ROADSTER 2014 Front Fuse Box Covers Replacement, Update ECM Software P1614, Hi Temp, Limp Home (RS, ST)_000071523_TST61Y014S00_en

Campaign no.: **2014-0001**

Subject: **Roadster Spyder™ RS and ST Series**
Subject 1 - Front Fuse Box Covers Replacement
Subject 2 - Update ECM Software (P1614, Hi-Temp Lamps, Limp Home Mode)

Subject 1

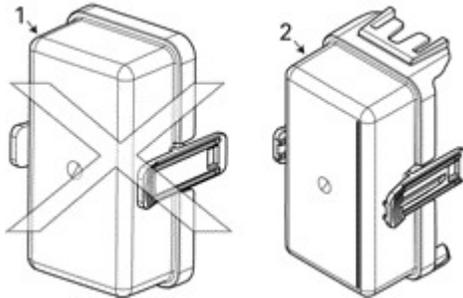
An improved fuse box cover is now used in production. Since this was a running change, a very limited quantity of vehicle were produced having a version of the fuse box cover which no longer meets BRP standards.

1. Old fuse box cover
2. New fuse box cover
3. Install new covers on fuse boxes. Make sure they are properly clipped.

Replace fuse box covers.

1. Remove the cover from both fuse boxes.
2. Transfer fuses to new covers.
